TECHNICAL MEMORANDUM

To: Aaron Zimmerman DDOT
From: Katie Wagner, PE, PTOE
Erwin Andres
Date: April 10, 2019
Subject: The Yards Parcel I – Response to DDOT Comments

Public Transit

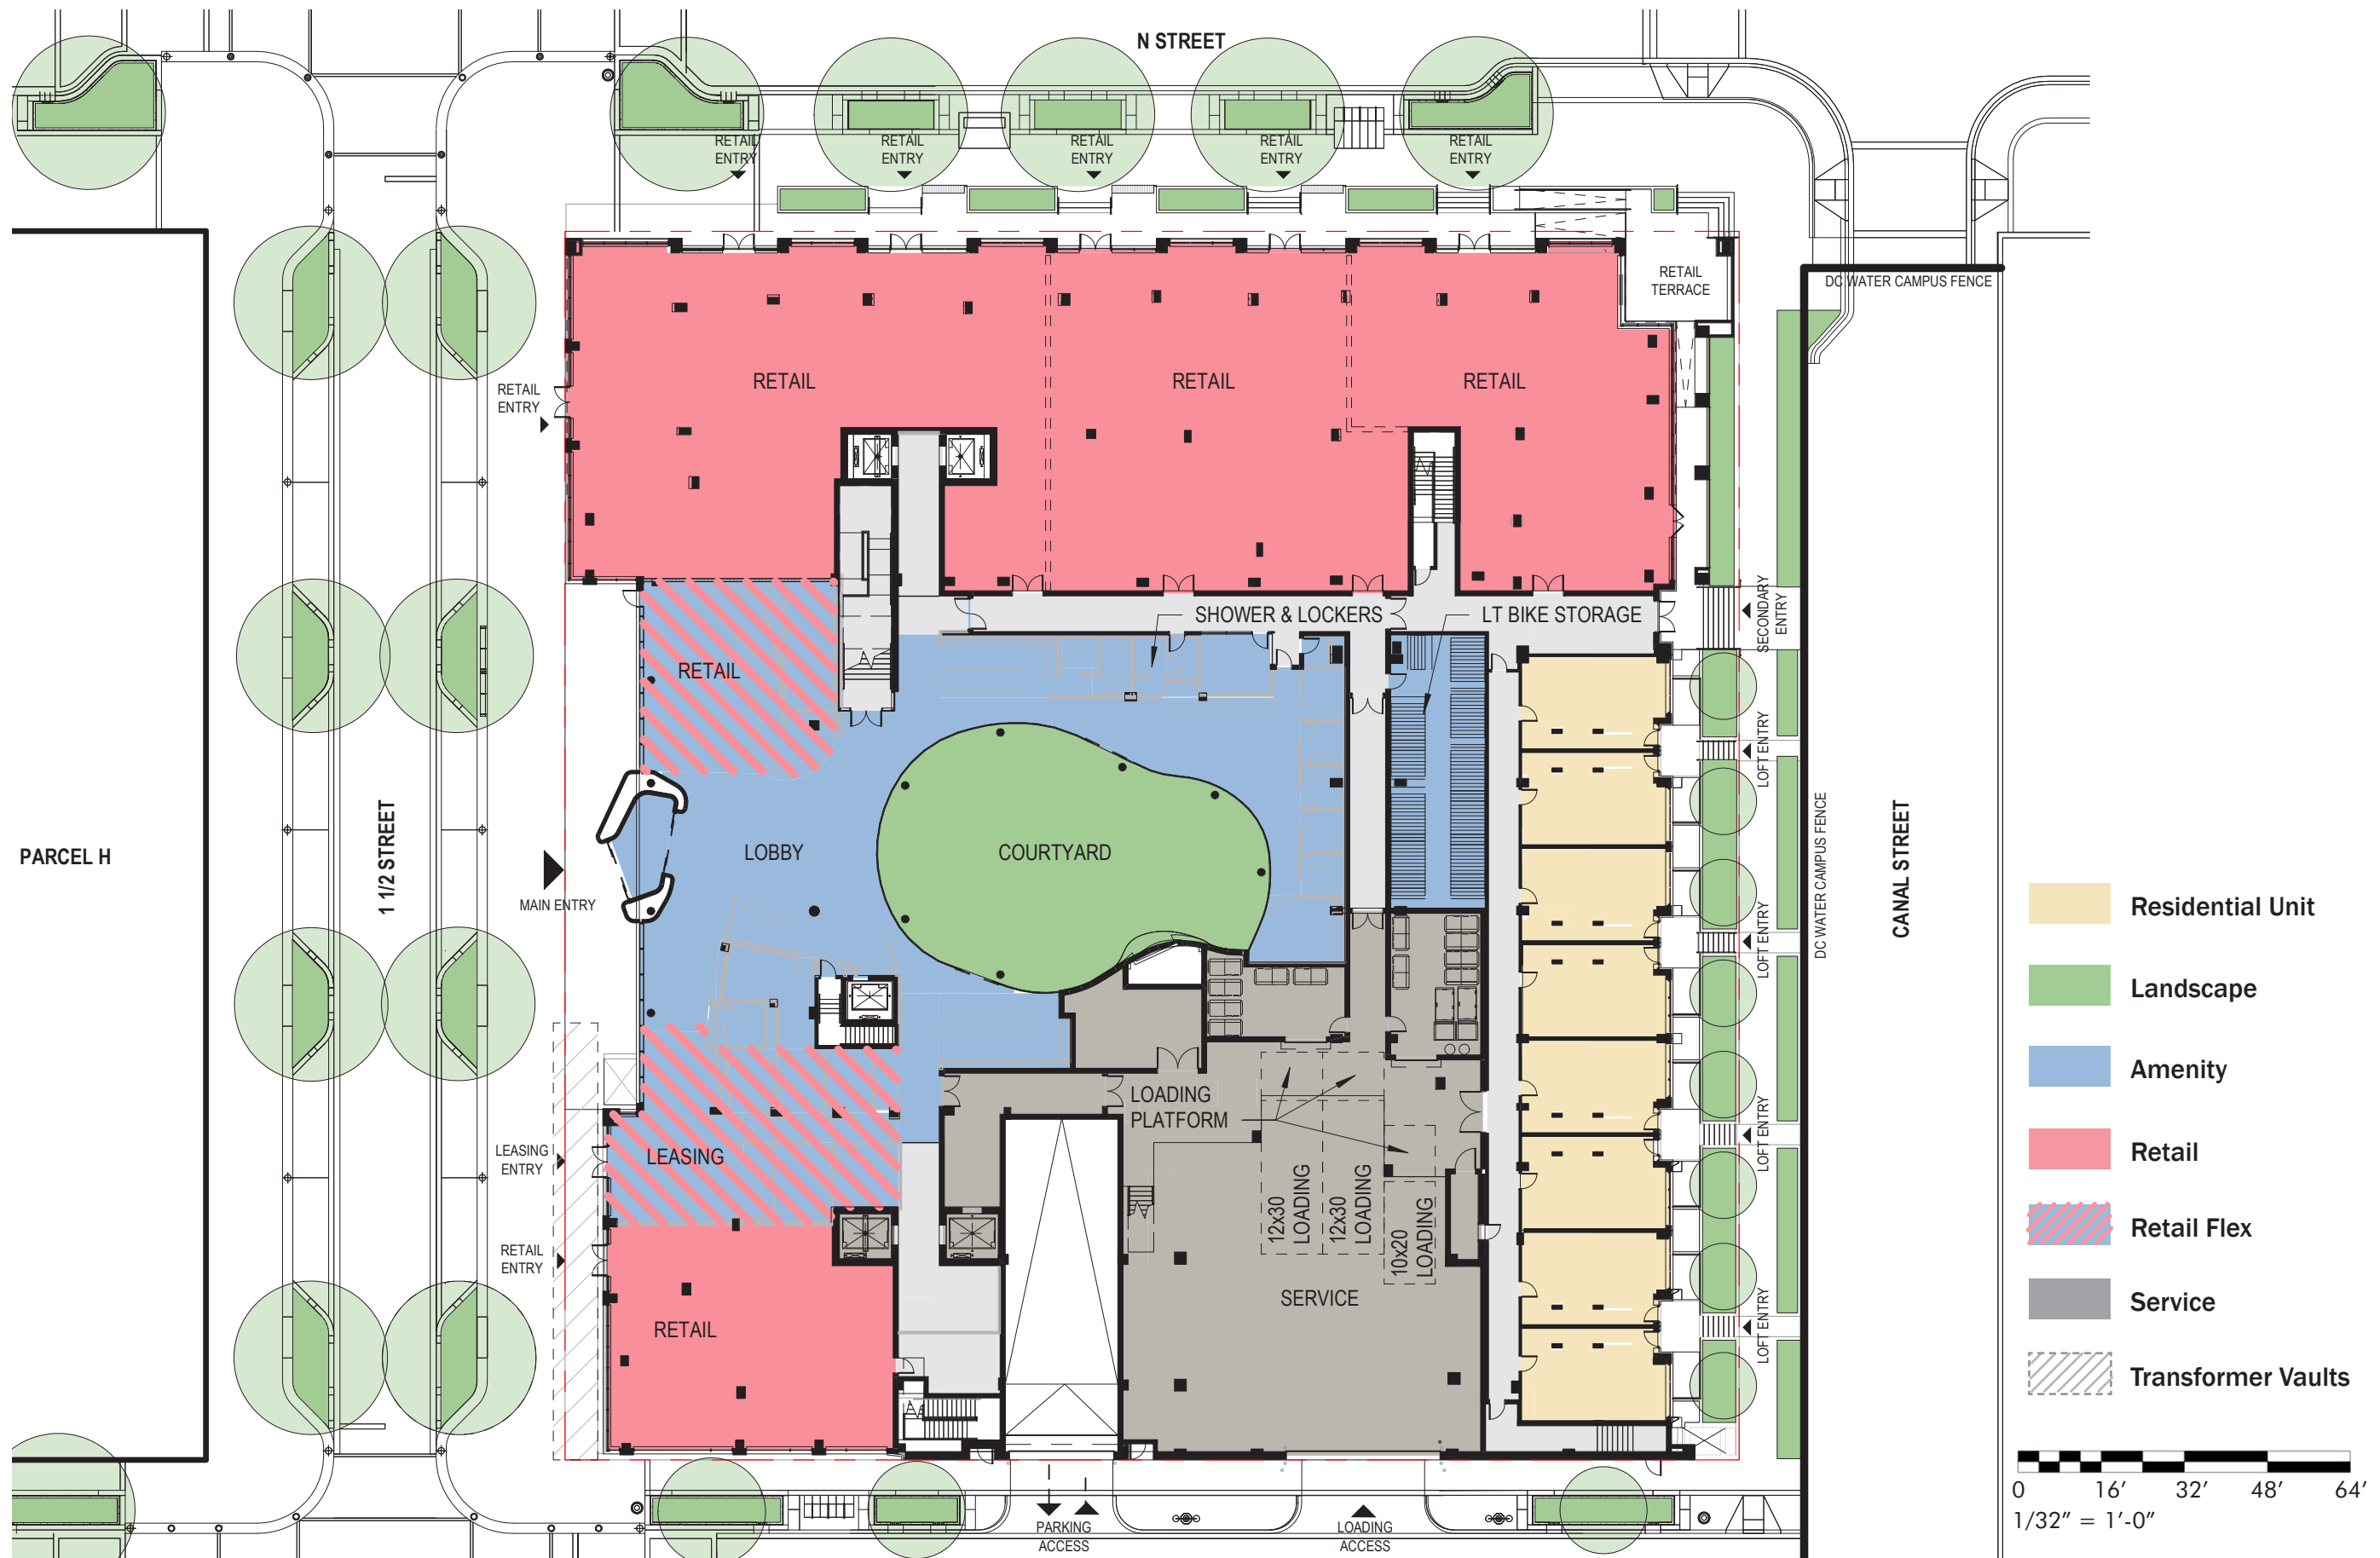
6. *Fund and install a 23-dock Capital Bikeshare station in the vicinity of the site, ideally on private property along 1 ½ Street SE, subject to DDOT approval;*

Response: As a part of the overall planning for Yards West, the applicant has considered Capital Bikeshare, and has planned for two other locations that make the most sense; at the north end, next to the potential third entrance to the Navy Yard metro, and at the south end, furthest away from the Metro and closest to the water, in general areas shown on the attached figure. Additionally, the applicant doesn't see a need for a station at this time as there is a 37-dock station one block west, on the east side of 1st Street adjacent to Parcel H. There is a 19-dock station one block east, on the north side of Tingey Street across from Parcel L/Tingey Square. We believe this is a TDM measure that is better addressed when other parcels are developed in Yards West.

Floor Plan - Level 1

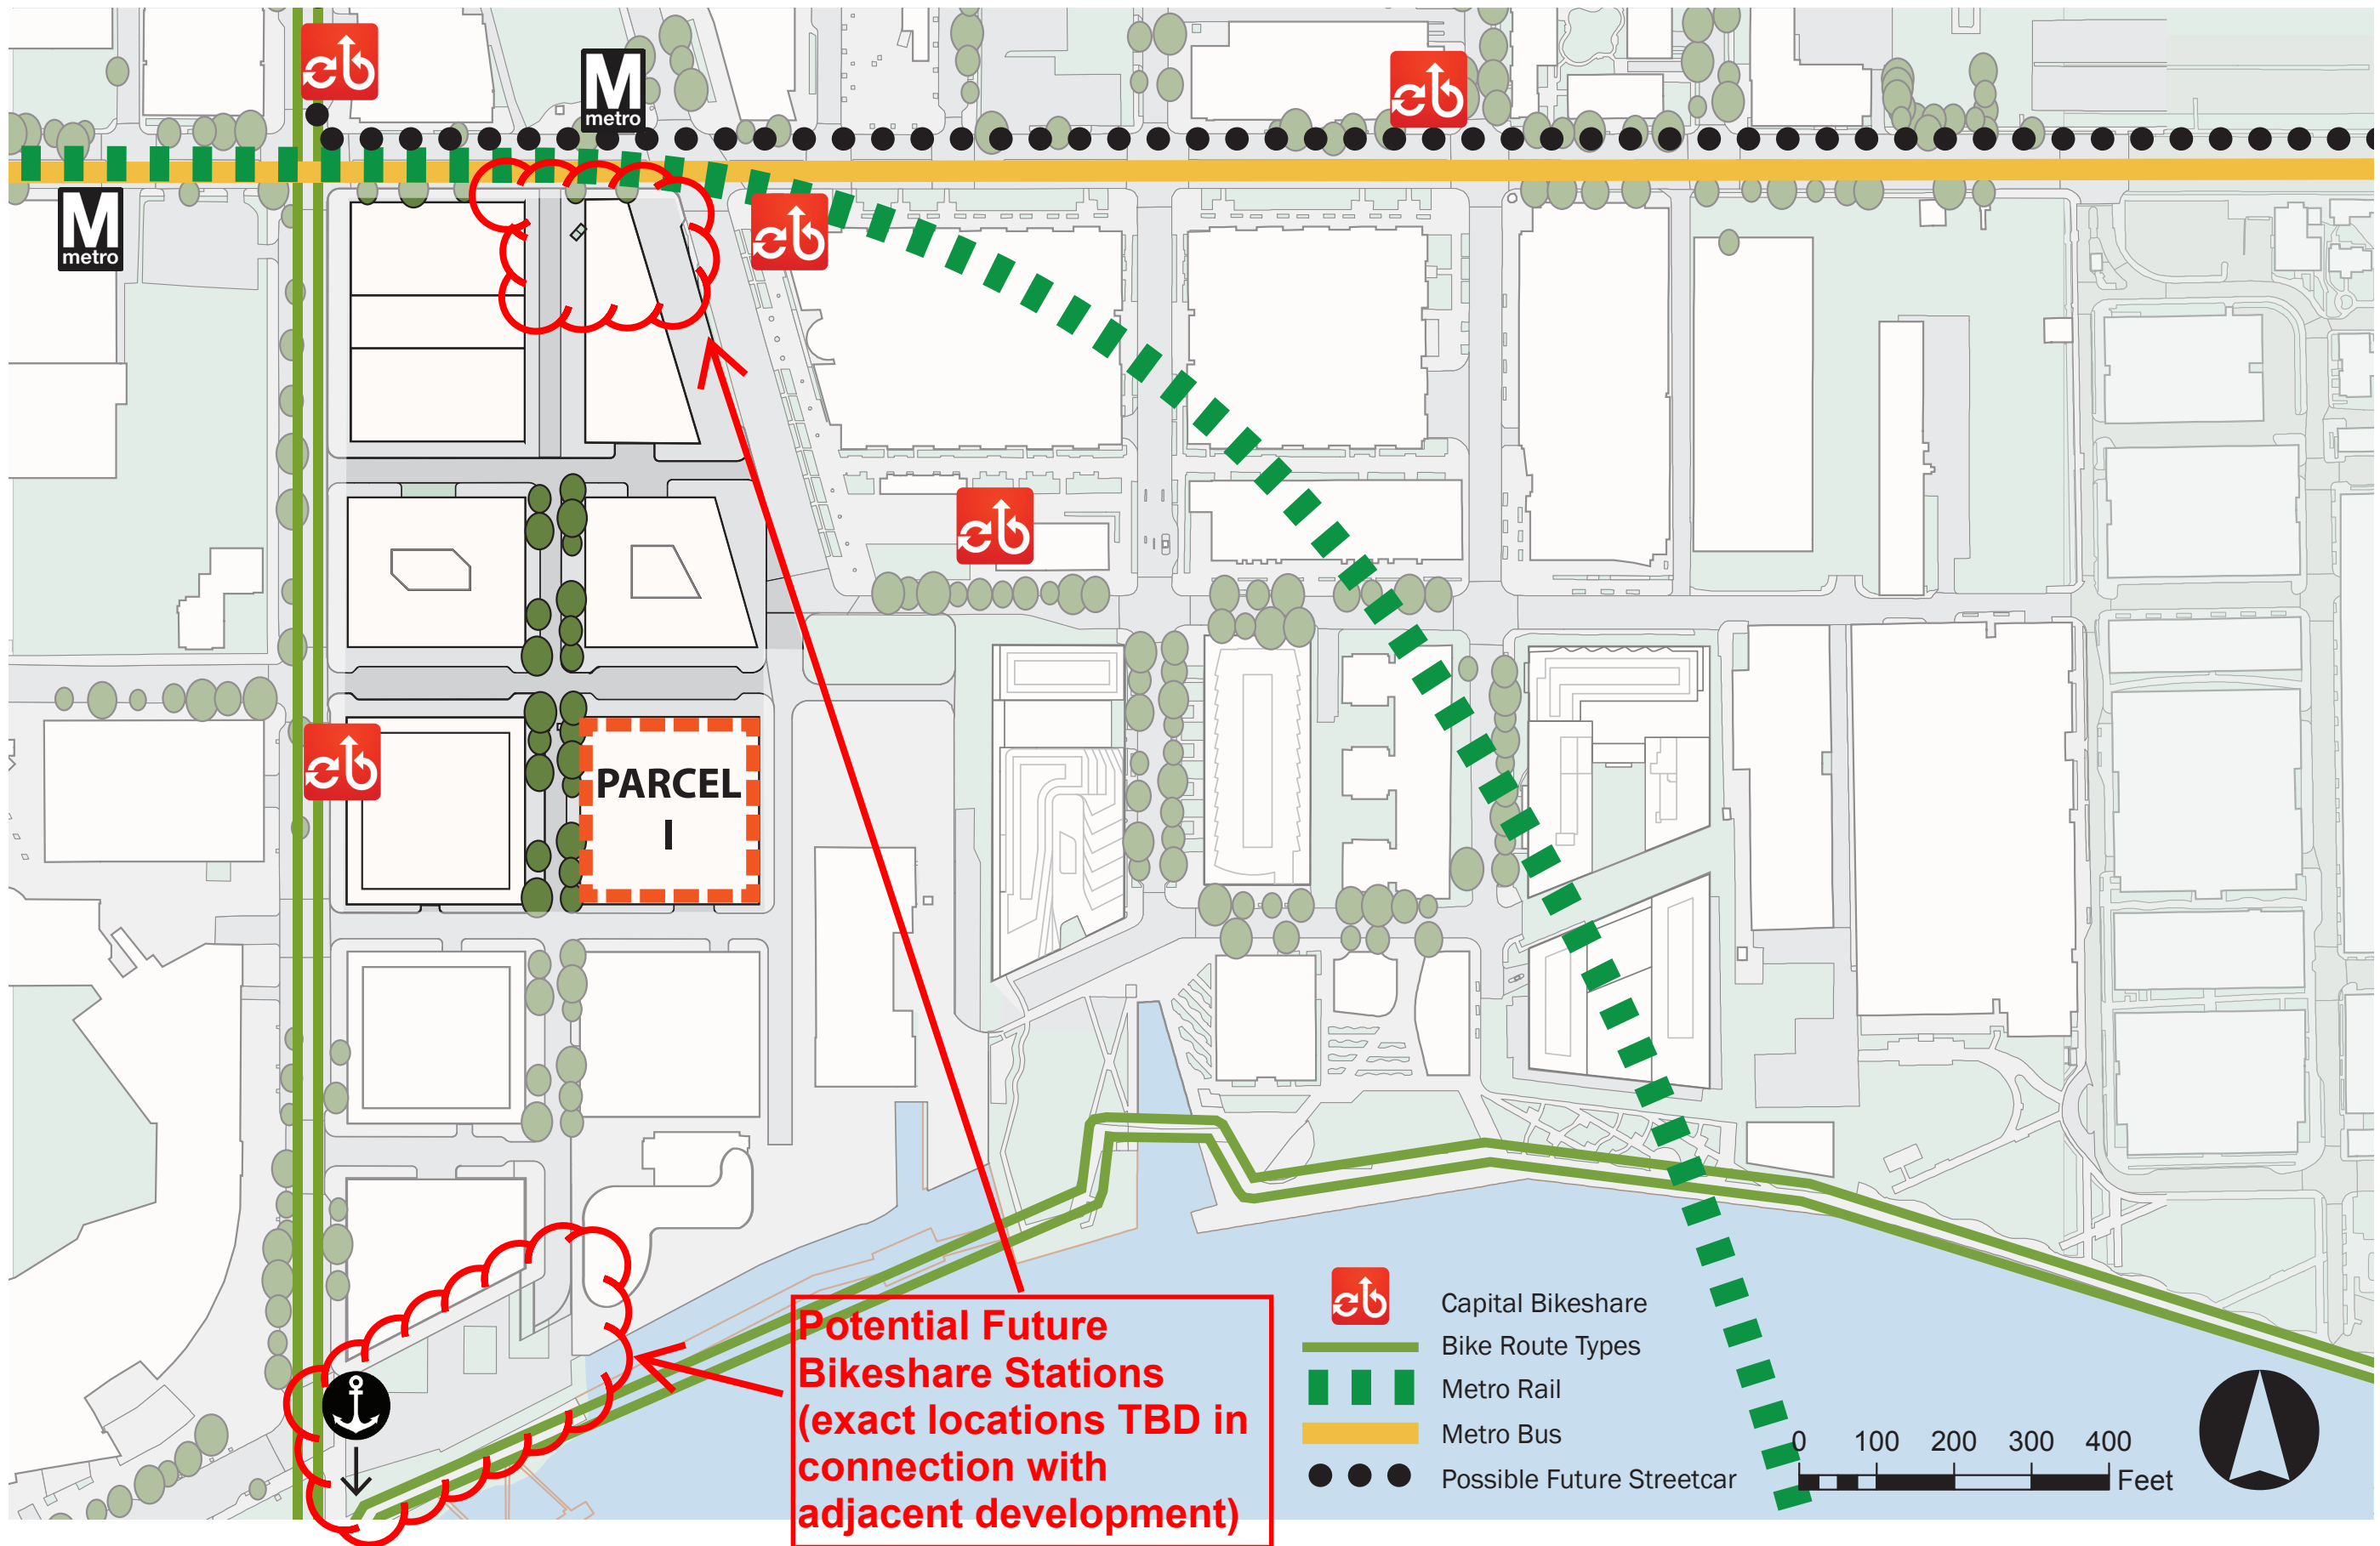
- 1. The proposed two (2) 30-foot loading berths and one (1) 20-foot delivery space meets ZR16 loading requirements. However, it is not clear if the ZR16-required loading platforms are included with the berths. They should be shown on the plan set;*

- 2. It is not clear where the long-term bicycle storage rooms are located based on the October 12, 2018 plan set (Exhibit 2k). The plans should be revised to show the storage room(s) in easily accessible location(s) within the building or parking garage, as close to the ground floor as possible, and near the elevator or lobbies;*

Response: The applicant agrees to this site design element as shown on the attached plan.

Response: The applicant agrees to this site design element as shown on the attached plan.
